Re: Tract N-1-B Watershed Subdivison - Sketch Plat Submittal

Development Facilitation Team (DFT) – Review Comments

Project No: PR-2024-010571 Date: 7/3/2024 Agenda Item: #12 Zone Atlas Page: J-8

Project: Tract N-1-B Watershed
Subdivision Agenda Item No: 12

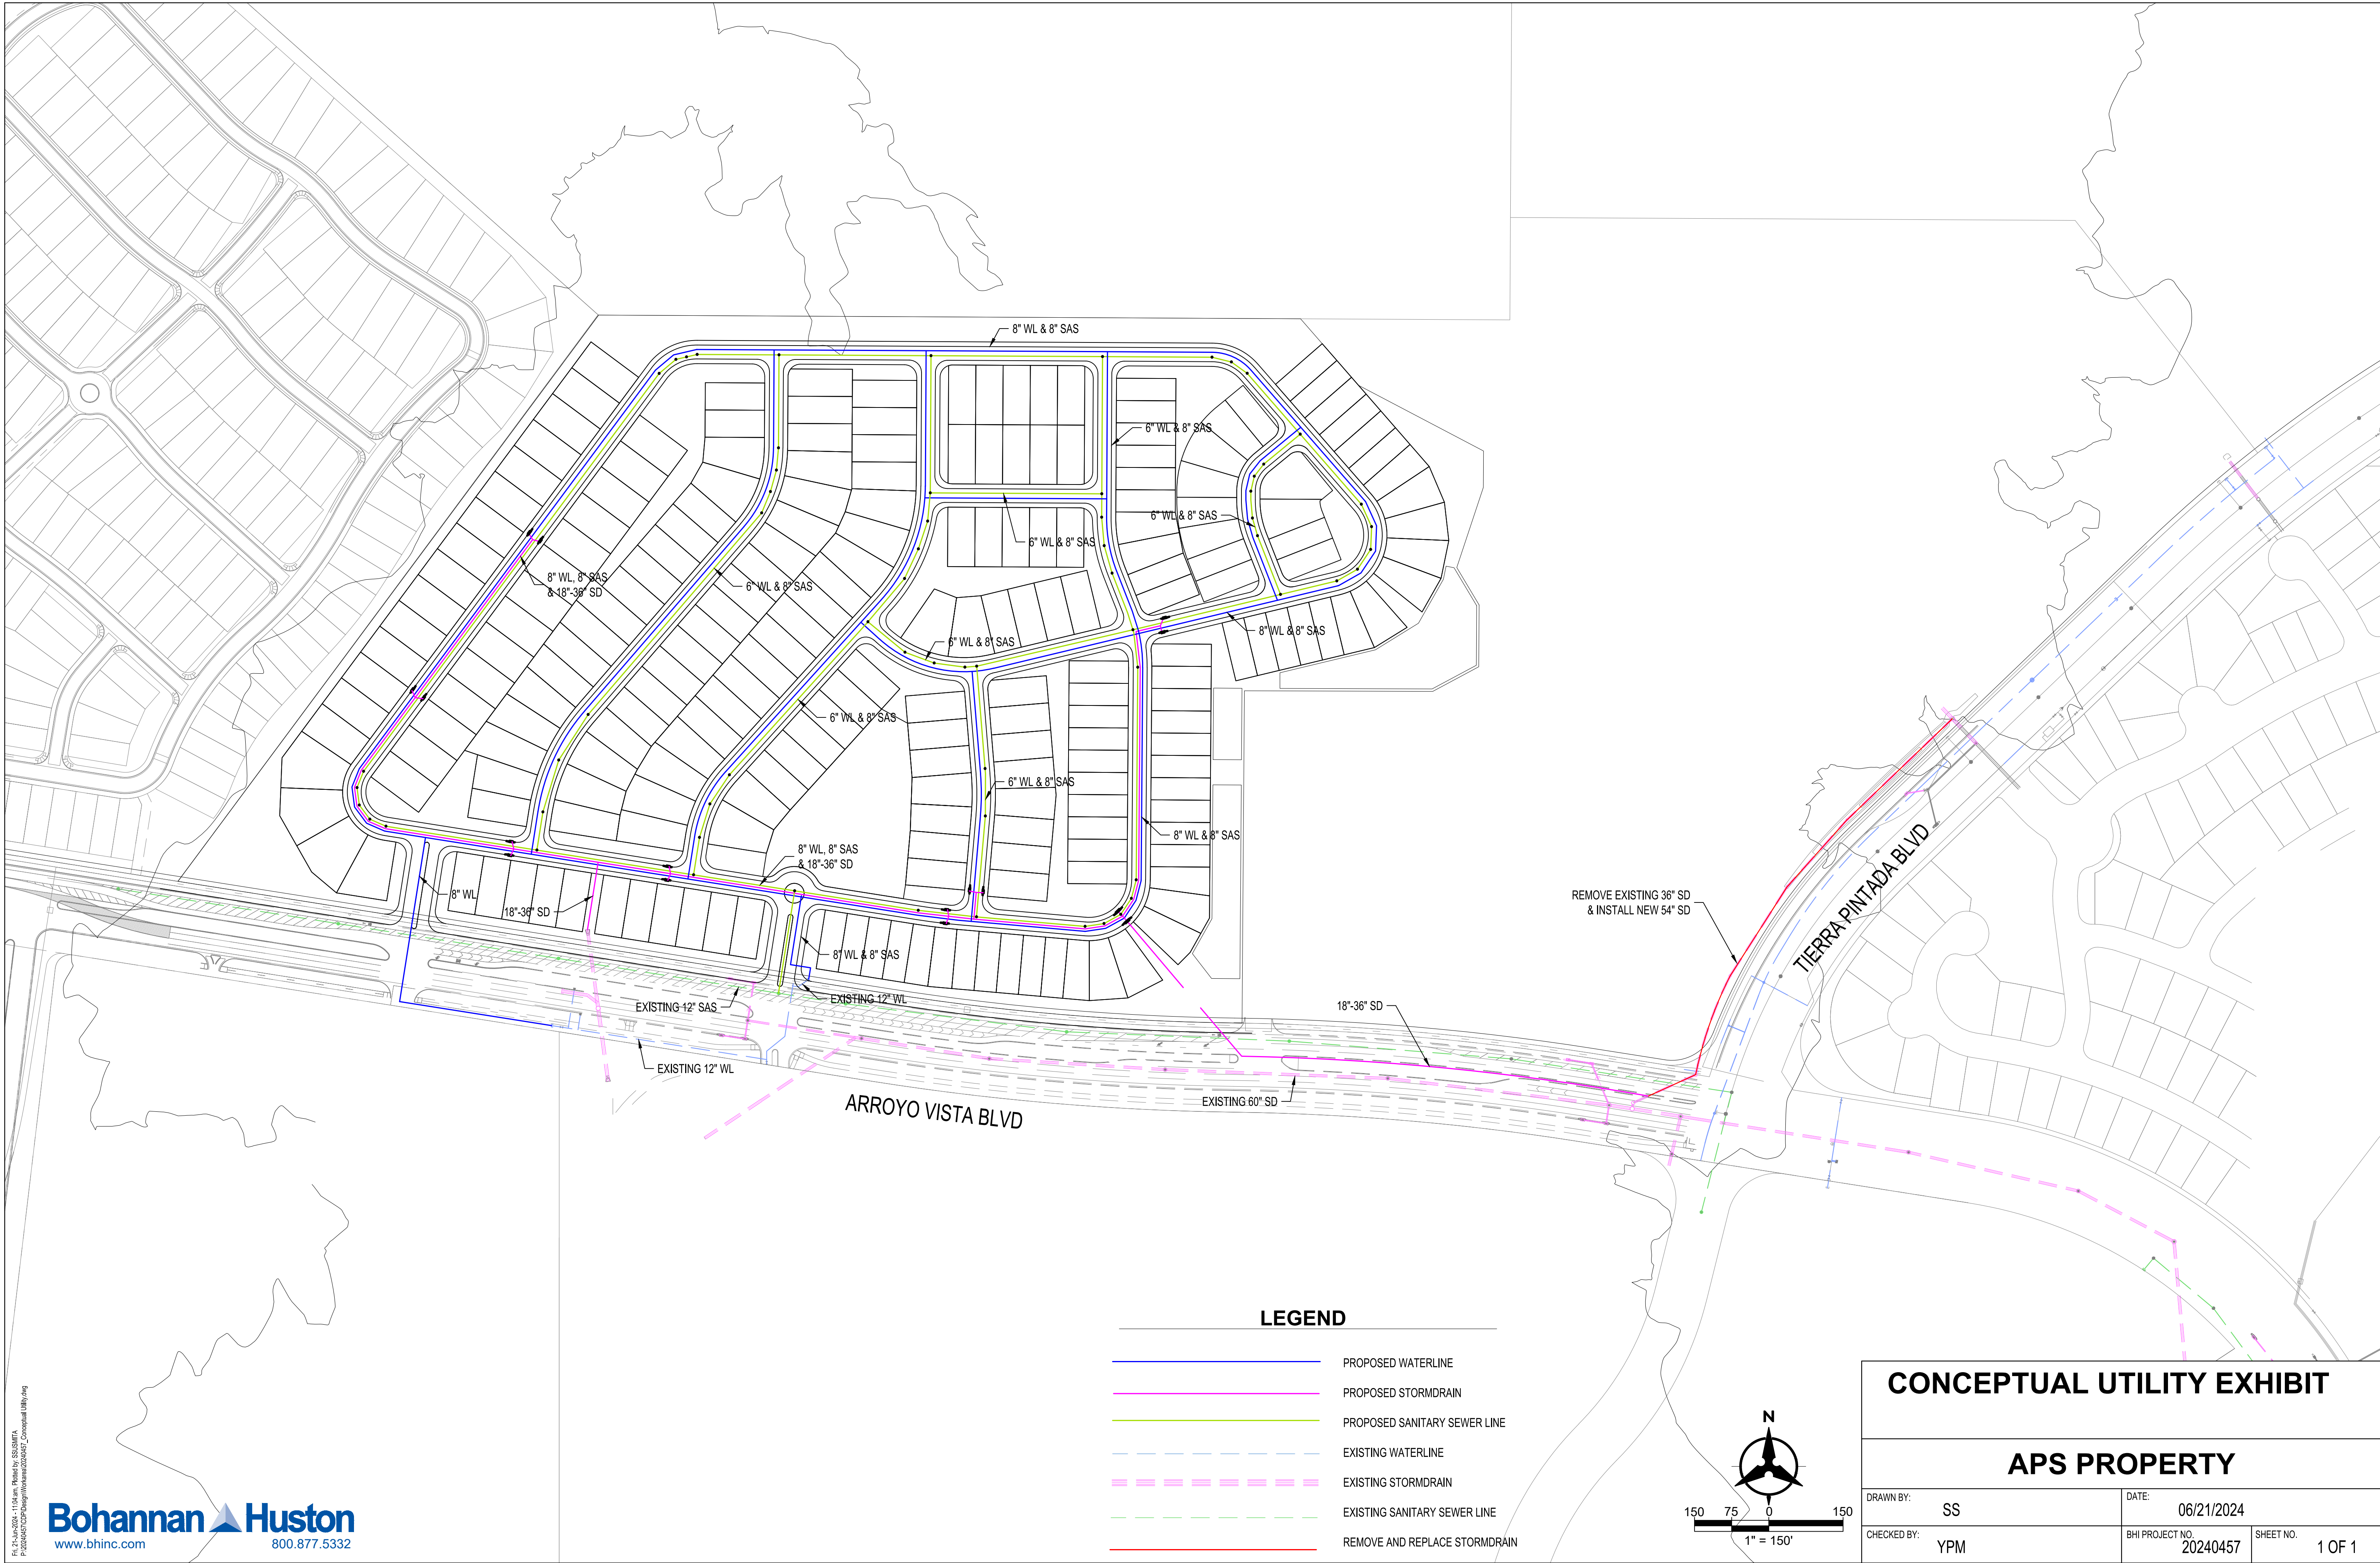
It is noted that a single-loaded street has been placed on the edge of the subdivision adjacent to Petroglyph National Monument which meets of the requirements of 5-2(J).

It would appear that you have been able to keep some block lengths under 600 feet, but some are not.
